**ADDITIONS AND MAJOR RENOVATIONS AT  
HARVARD H. ELLIS TECHNICAL HIGH SCHOOL  
613 UPPER MAPLE STREET  
DANIELSON, CONNECTICUT  
PROJECT BI-RT-841**

<b>BID OPENING</b>	<b>1:00 P.M.</b>	<b>AUGUST 3, 2011</b>
<b>ADDENDUM NUMBER 3</b>	<b>DATE OF ADDENDUM</b>	<b>JULY 25, 2011</b>

Sketch No.  
**SKM-29**  
 BR-RT-641

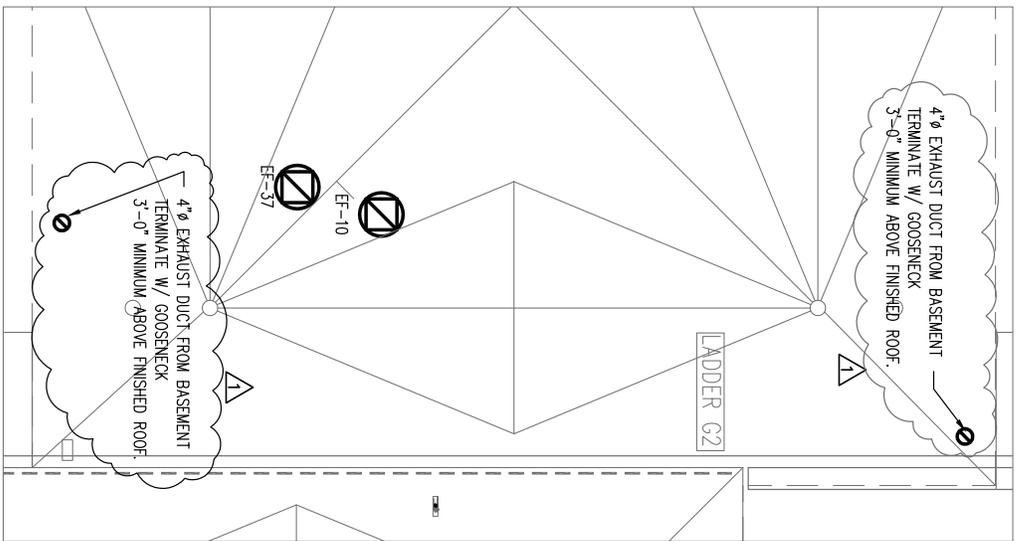
See Sketch SKM-29 – “First Floor Ductwork Partial Plan – Part G” – **ADD** tunnel ventilation systems.

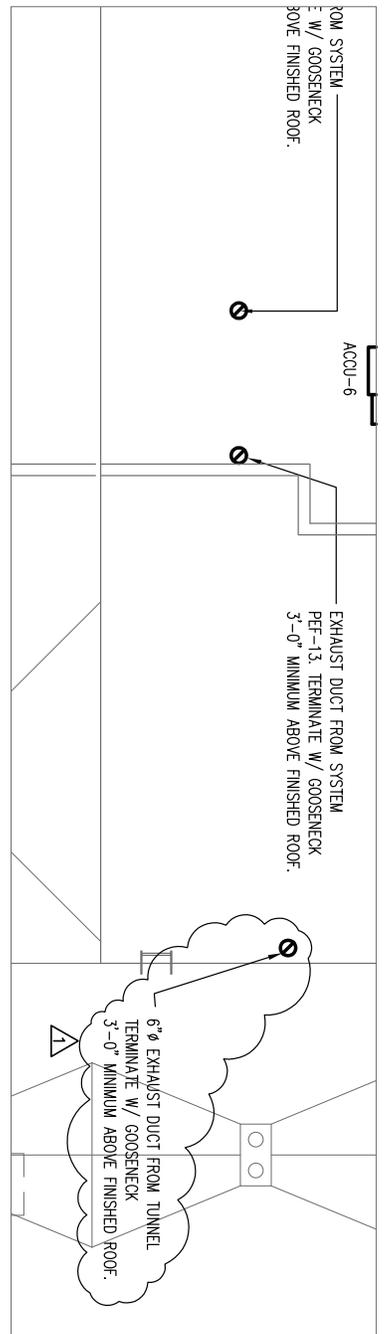
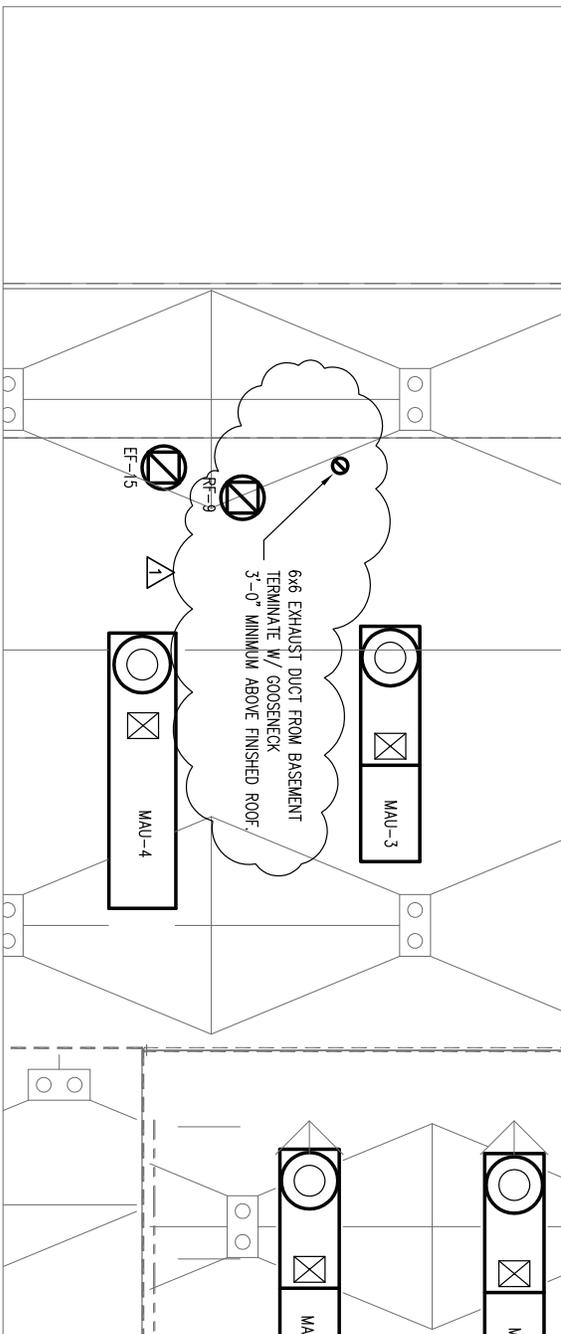
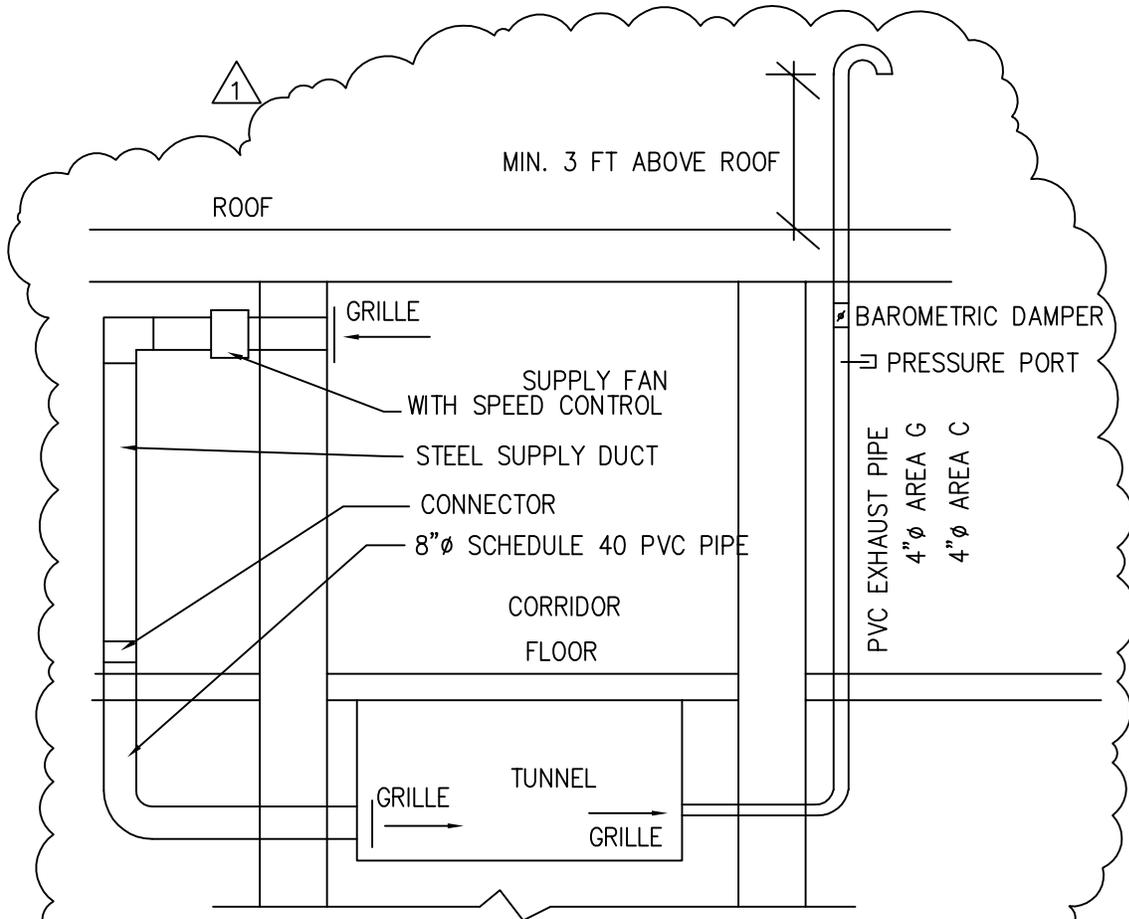
1. See Sketch SKM-30 – “Roof HVAC Partial Plans – Parts C, G, E1-F” – **ADD** tunnel ventilation systems and radon exhaust fan RF-9.
2. See Sketch SKM-41- “Radon Exhaust Fans Location” – **ADD** radon exhaust fans RF-6, RF-7

Sketch No:  
**SKM-31**  
**BI-RT-841**

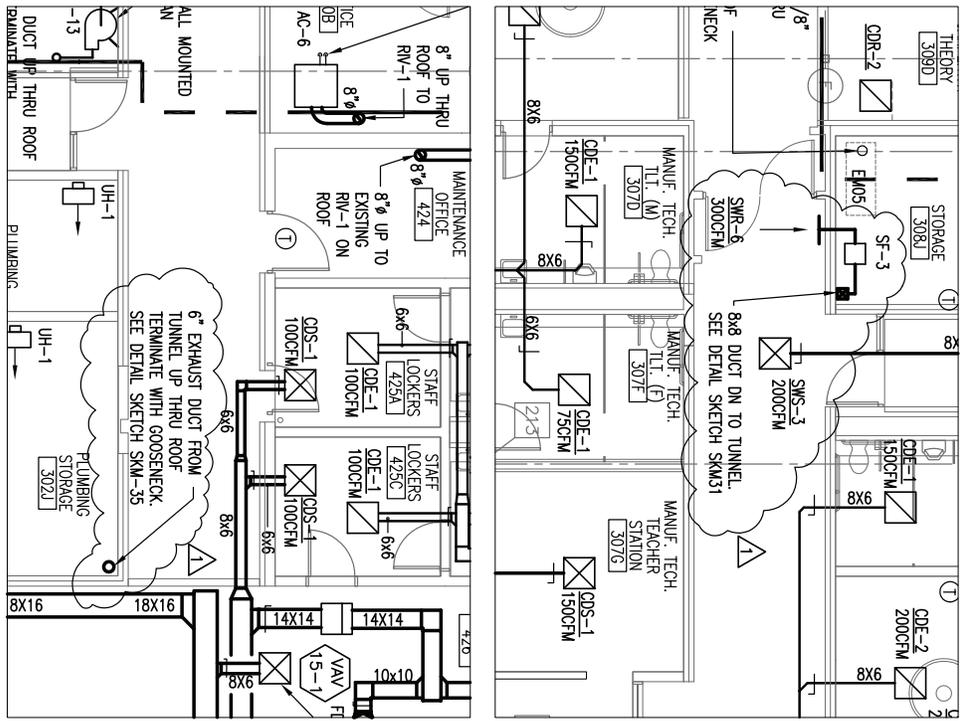
1. See Sketch SKM-31 – “Detail – Existing Tunnels Ventilation” – **ADD** detail of tunnel ventilation systems.

Scale:	As Noted	Sheet No:	<b>SKM-34</b>
Reference:	MMB E-F	Date:	JULY 23, 2011
Proj. No.:	04/79/00	Rev. No.:	BT-441

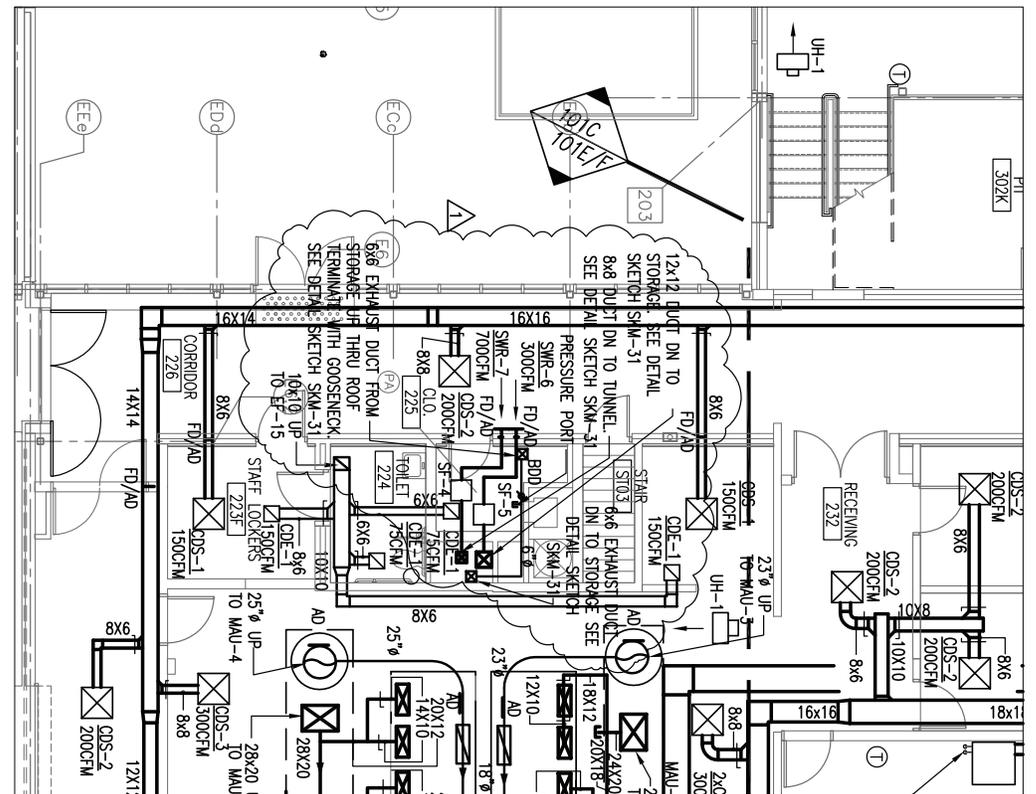
- a. See Sketch SKM-34 – “First Floor Ductwork Partial Plans – Parts B, E1-F” – **ADD** tunnel ventilation systems

**AUTOMATIC SMOKE DAMPER INSTALLATION**  
**H.H. Ellis Technical High School**  
Additions + Major Renovations  
Danelson, CT

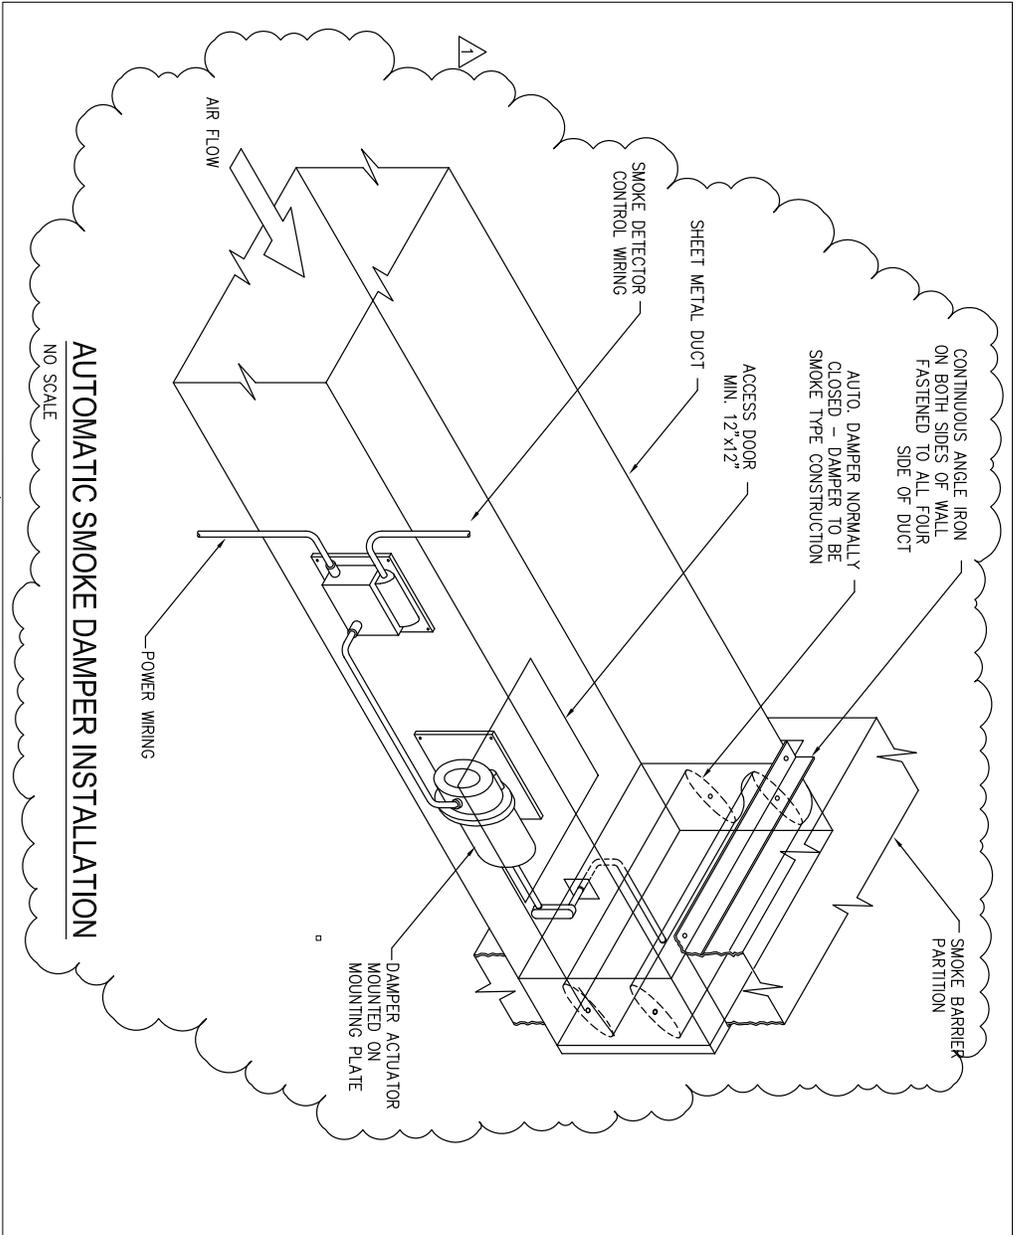
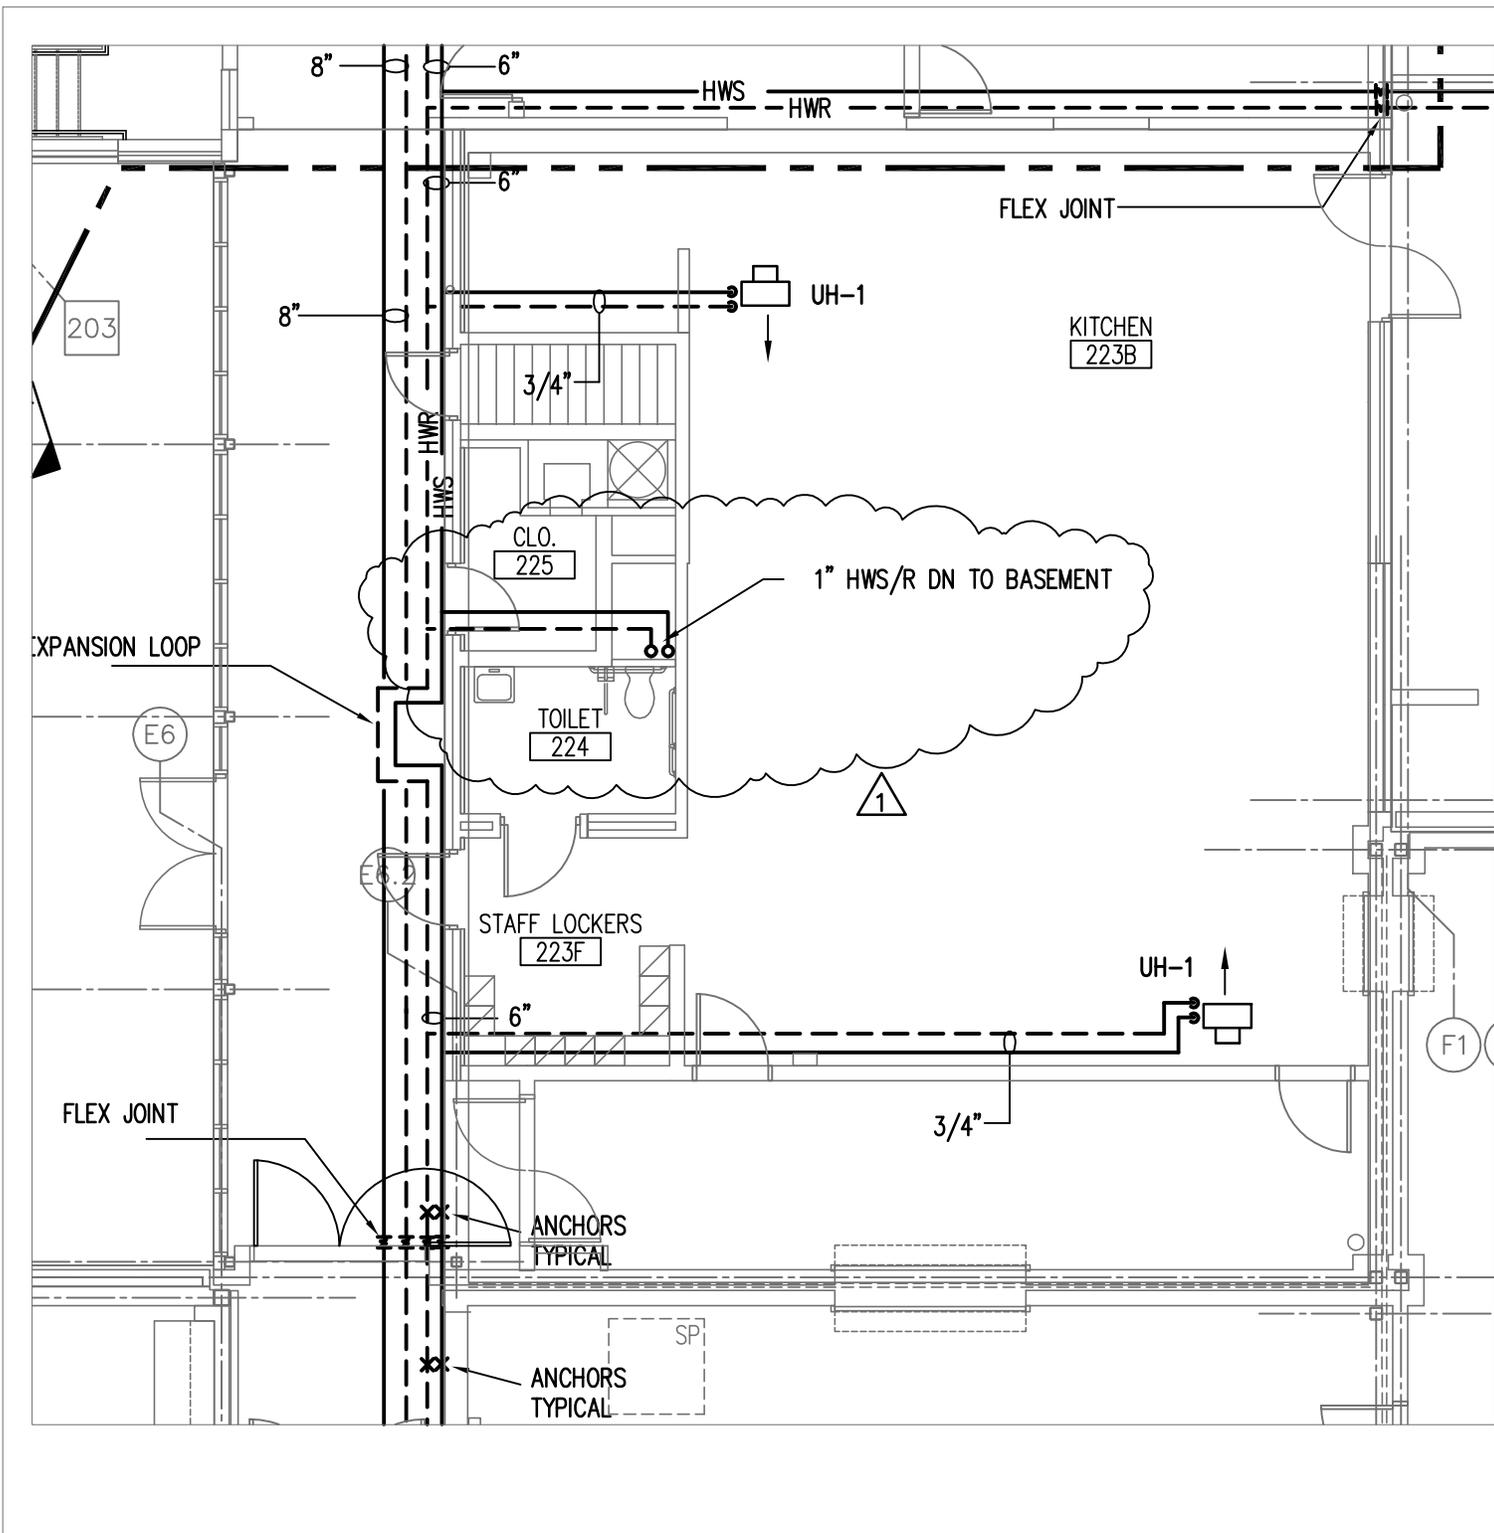
1. See Sketch SKM-35 – “Automatic Smoke Damper Installation” – **ADD** detail of smoke damper.

PROVIDE MINIMUM 1/4" MAXIMUM 1/2"  
 CLEARANCE FOR DAMPER EXPANSION  
 ON BOTH SIDES & TOP SEAL  
 CLEARANCE WITH FIRE RETARDANT  
 CAULKING

ACCESS DOOR MIN. HEIGHT  
 12" OR 1" SMALLER THAN  
 DUCT HEIGHT 12" MINIMUM  
 HEIGHT

## DETAIL OF SIDEWALL REGISTER WITH FIRE DAMPER

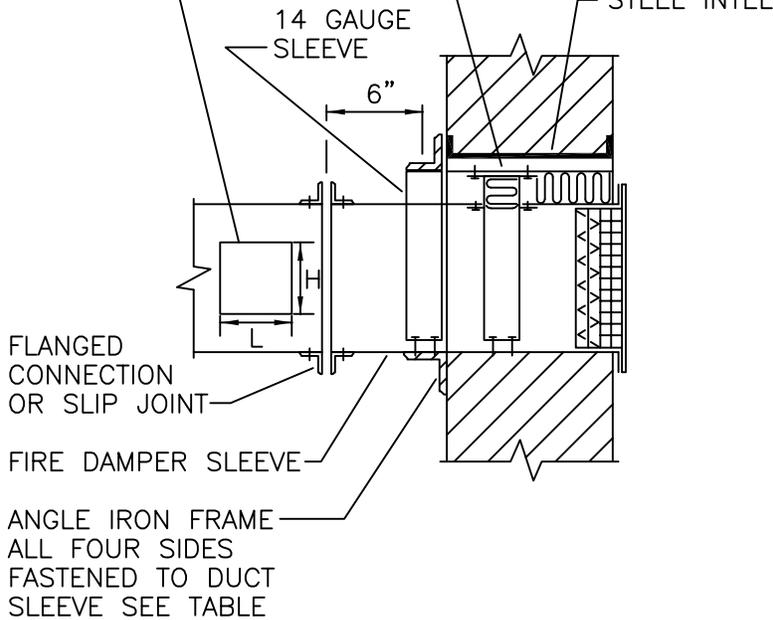
1. See Sketch SKM-37 – “Detail – Of Sidewall Register with Fire Damper” – **ADD** detail of sidewall register with fire damper.

# PROCESS EXHAUST FAN

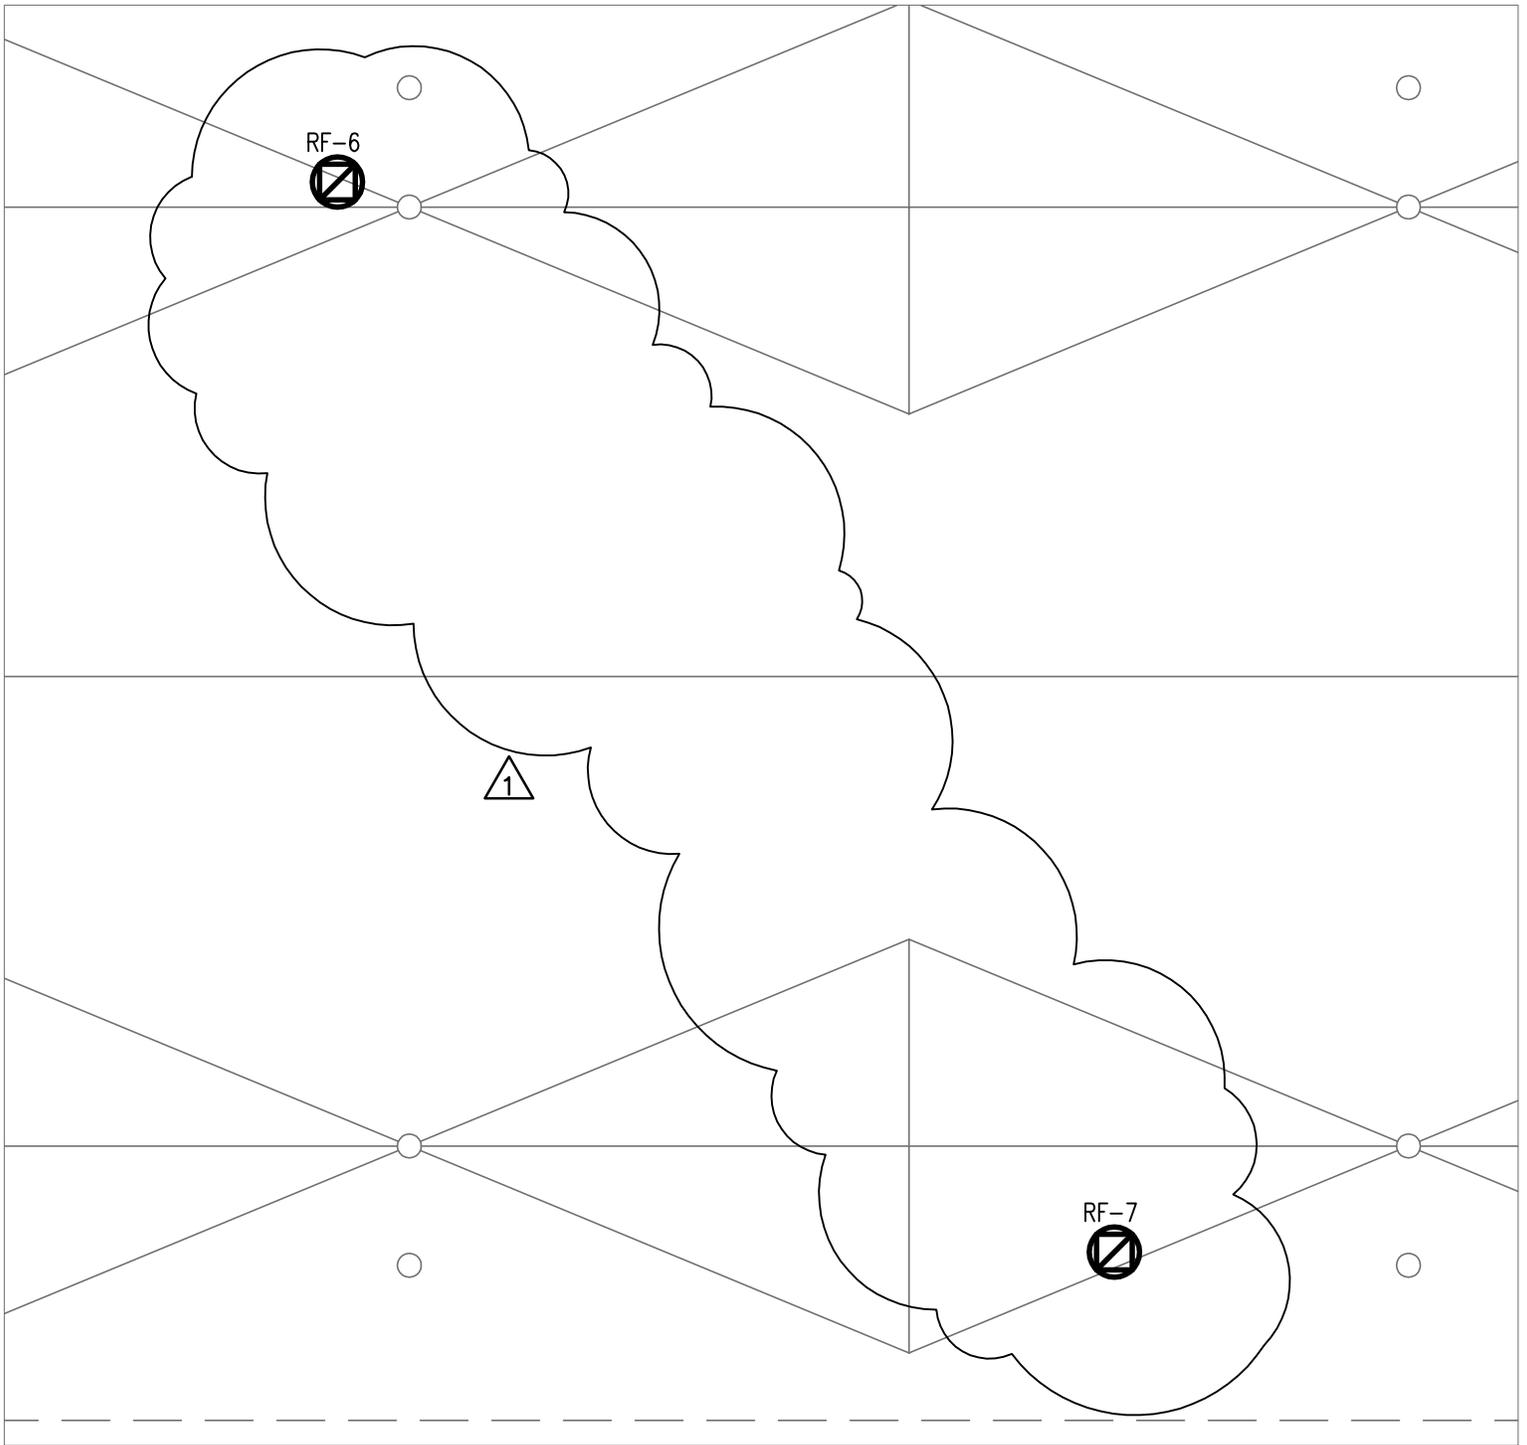
1. See Sketch SKM-40 – “Process Fans Schedule” - **ADD** radon exhaust fans from RF-6 thru RF-9.
